# REGIONAL REVIEW NOTIFICATION

Name of Proposal: 2023 Chastain Meadows DRI 3940

<u>Description:</u> A DRI review of a proposal to construct a mixed-use project with 425,000 SF of light industrial space in three buildings, 140 townhomes, 220 age-restricted multifamily units, 22,500 SF of restaurant space, and 7,500 SF of retail space on an approximately 57-acre wooded site located on Chastain Road in unincorporated Cobb County.

**EX-1**

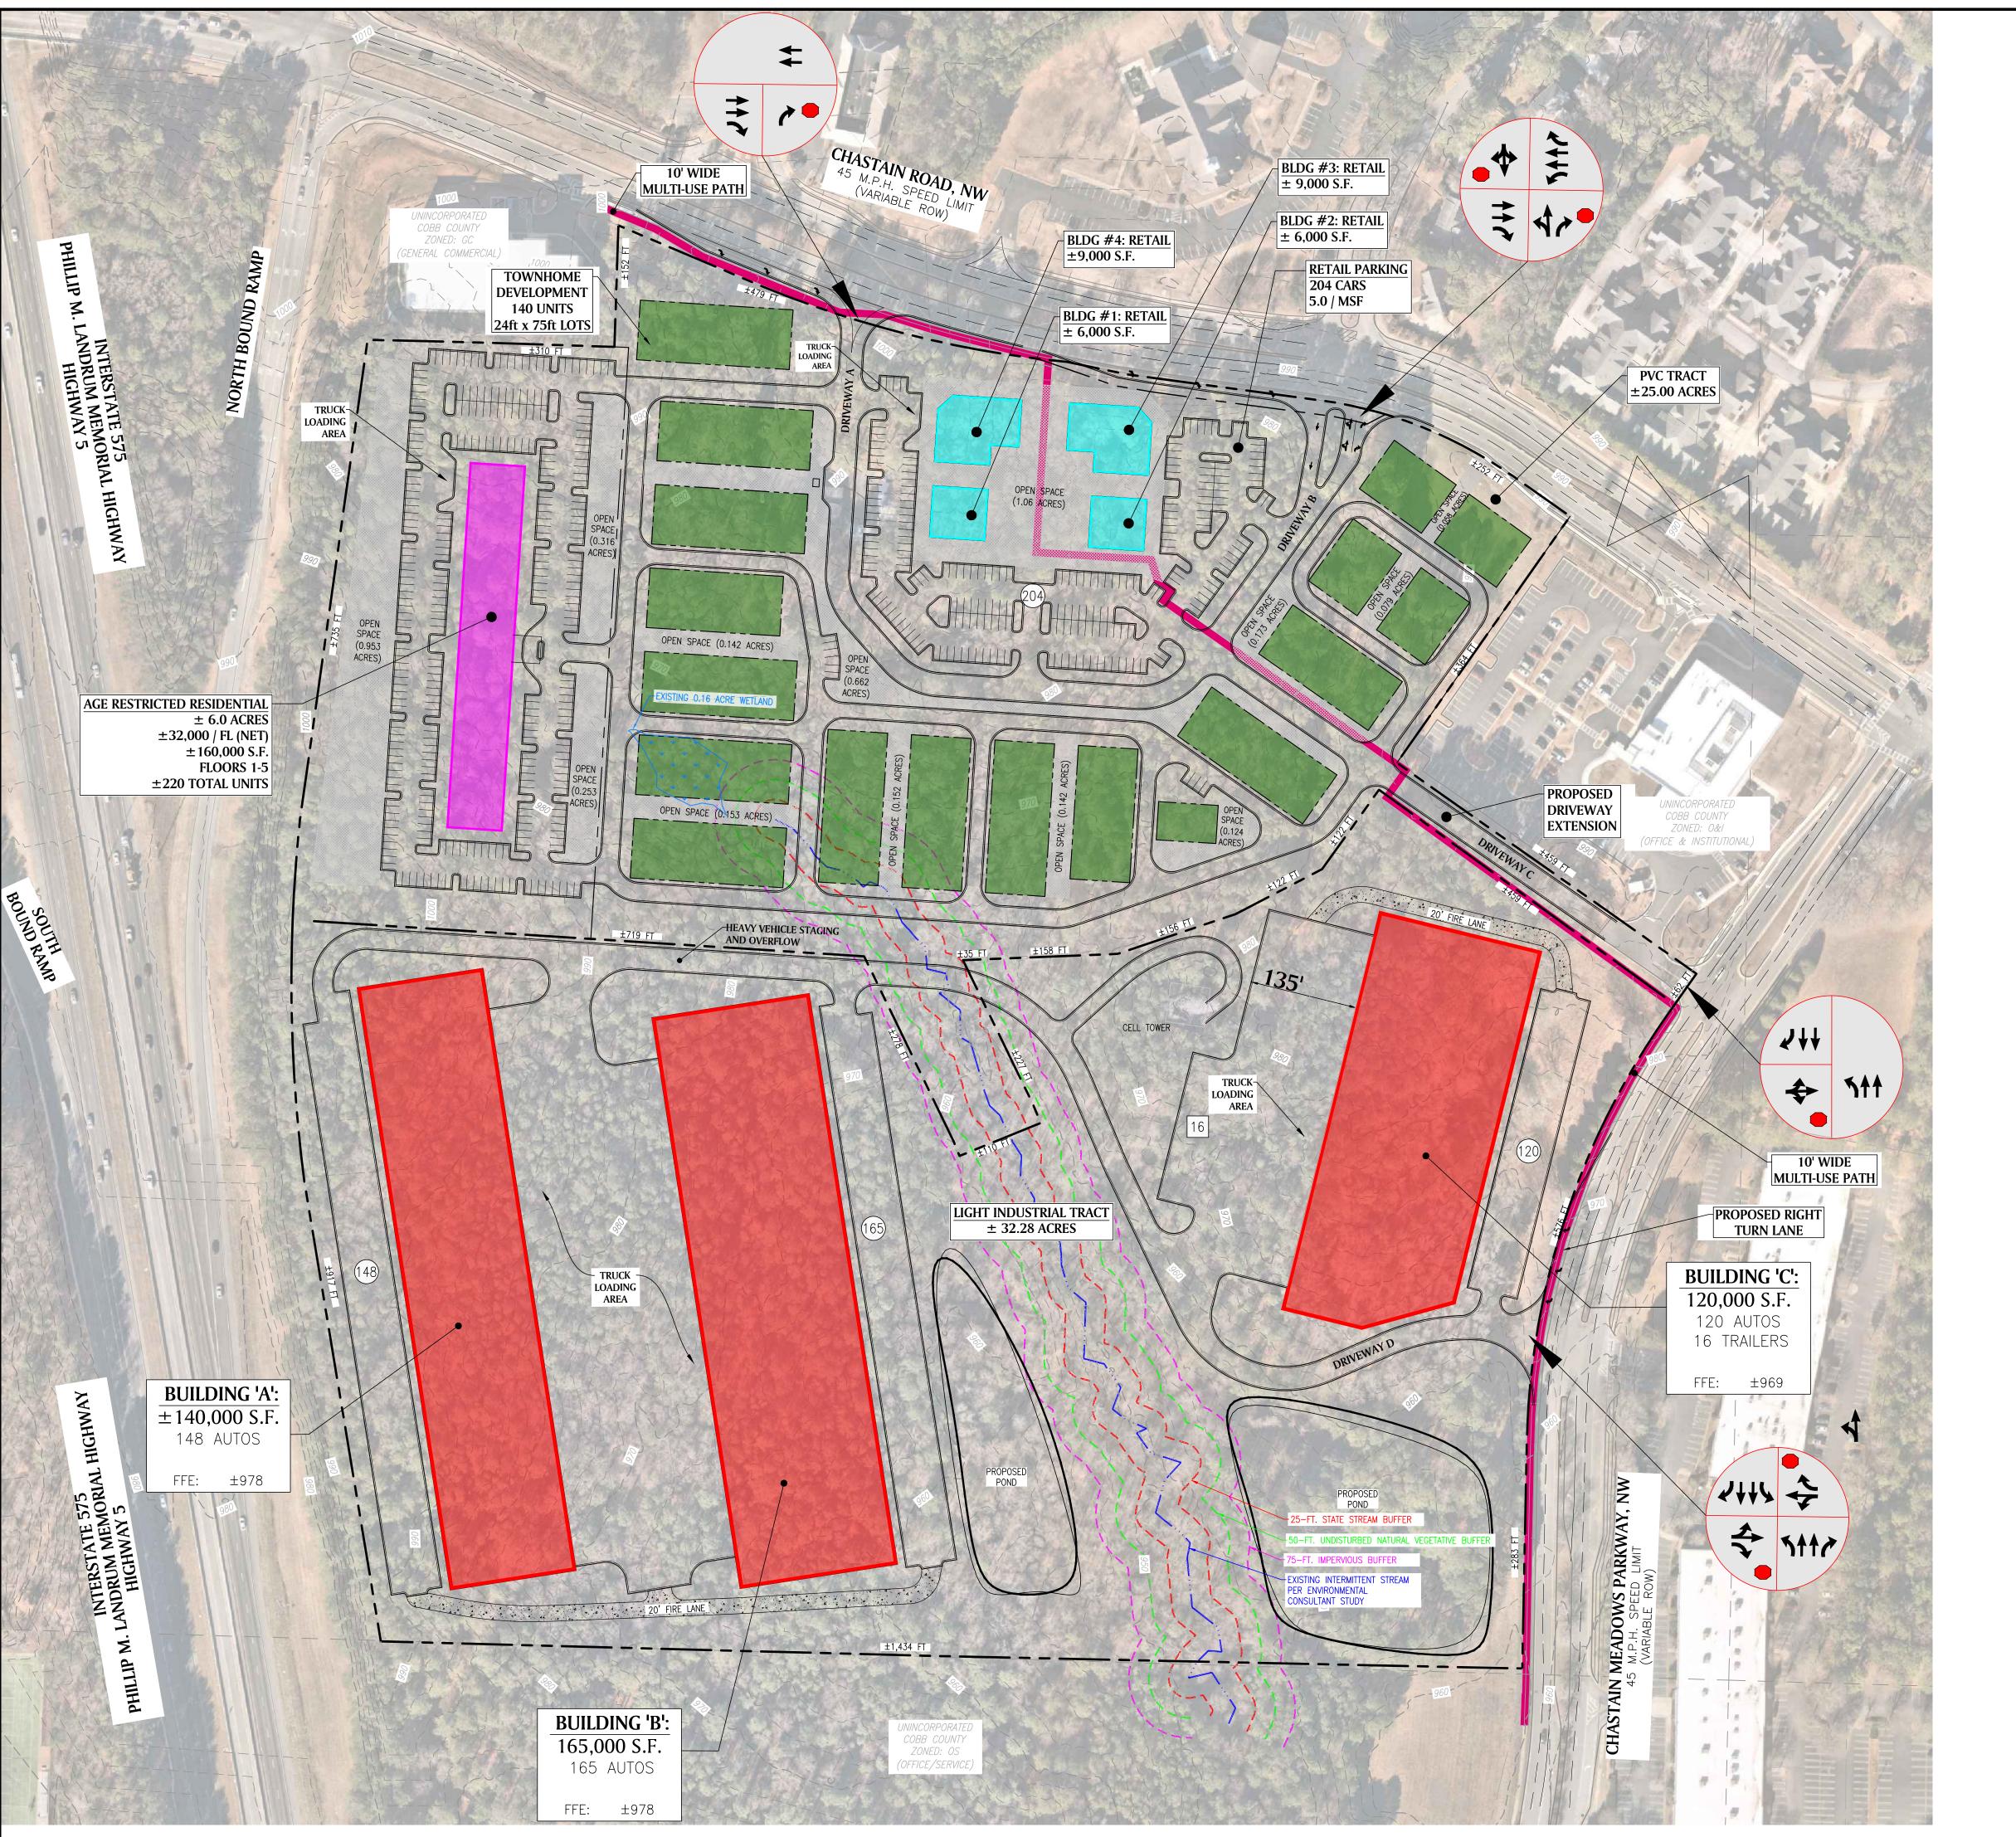
The project will remove a wetland area and a significant portion of the stream located on the site including the stream headland which is not supportive of regional environmental policies.

A total of 1,247 parking spaces are proposed which is 274 (28%) more than the 973 required; a reduction in parking spaces would be supportive of regional transportation policies.

The project does not appear to include bicycle parking spaces and EV charging spaces; provision of adequate numbers of both would be supportive of regional multi-modal transportation policies.

A planned multi-use trail is shown along Chastain Road and then traversing the interior of the site to connect to Chastain Meadows Road. The proposed route would provide trail users with access to retail amenities and activate the site which is strongly supportive of regional multi-modal transportation and urban placemaking policies. A sidewalk will still need to be provided along the trail's originally planned route along Chastain Road to the east.

A planned multi-use trail is shown along Chastain Road and then traversing the interior of the site to connect to Chastain Meadows Road. The proposed route would provide trail users with access to retail amenities and activate the site which is strongly supportive of regional multi-modal transportation and urban placemaking policies. However, a sidewalk will still need to be provided along Chastain Road where the trail was initially planned.

The project site is one of the last remaining large wooded parcels in the neighborhood and provides meaningful carbon sequestration and heat island mitigation/urban cooling functions for the surrounding area. Only 4 of the site's 57 acres are to be retained as open space which is scattered around the site. The project also proposes the removal of wetlands and a significant portion of the stream located in the site which is not in keeping with regional environmental policies. Ideally the building footprints could be adjusted to limit the significant negative wetland and steam impacts, to provide some additional open space/retained wooded area, and to consolidate the existing space provided in order to better retain some of the existing trees. The construction approach should further attempt to retain existing trees wherever possible.

The central undeveloped space between the warehouse building footprints adjacent to the stormwater ponds presents an opportunity to create a functioning natural area.
